## Technical Newsletter

No:  
33

3rd screw added on main cover for Minor, Major, Senior & Sandy

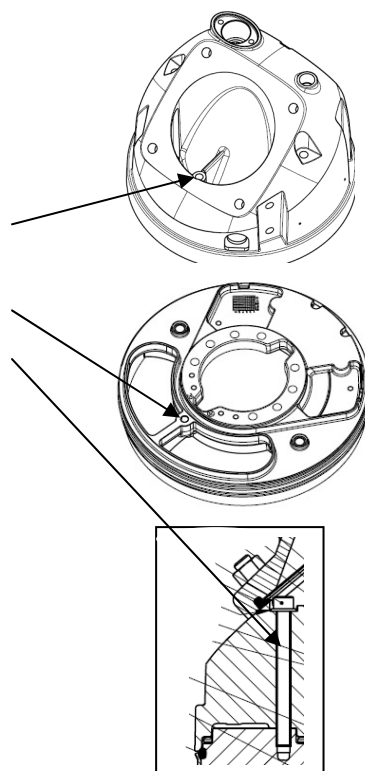
The main cover (pos 6) & the cover (pos 37) on pump model Minor, Major, Senior & Sandy are modified to fit a third screw when assembling the main cover on the cover.

Improve the robustness of the pump & improve the sealing of the connection chamber.

The change is implemented from January 2011 from serial number -1110001.  
(for example 8103.180-1110001)

Denomination	Part number
Main cover (pos 6)	51 606 00
Main cover for level regulator (pos 6)	51 606 01
Cover (pos 37)	51 605 00
Screw M8x90	410736
Washer	5002138

Denomination	Part number
Main cover (pos 6)	<del>50 838 00</del>
Main cover for level regulator (pos 6)	<del>50 838 01</del>
Cover (pos 37)	<del>50 947 00</del>

The new main covers & covers have full Interchangeability with the replaced parts and will fit on earlier produced pumps, but the 3<sup>rd</sup> screw will then not be used.
